| Title of Change: | NCP3066 modify the description of RS/Rsense/ RSC / Ipk in datasheet |
| Effective date: | 10 Oct 2022 |

This Product Bulletin is to announce the change of NCP3066/NCV3066 datasheet as below
 Correct the noun definitions on the datasheet to be consistent with the design worksheet

Figure 1. Typical Buck Application Circuit

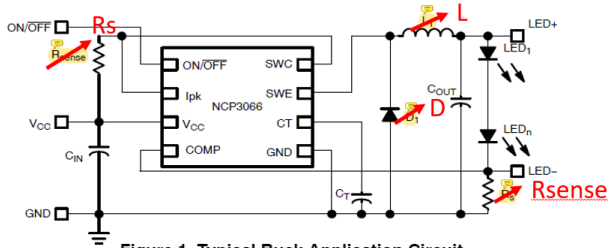
1. Figure 1. Component L1 change to L, D1 change to D
2. RSense change to Rs
3. Rsc change to Rs
4. Rs change to Rsense
5. Peak Current Sense change to Peak Current
6. Vref change to VTH
7. Pin name IpkSense change to Ipk
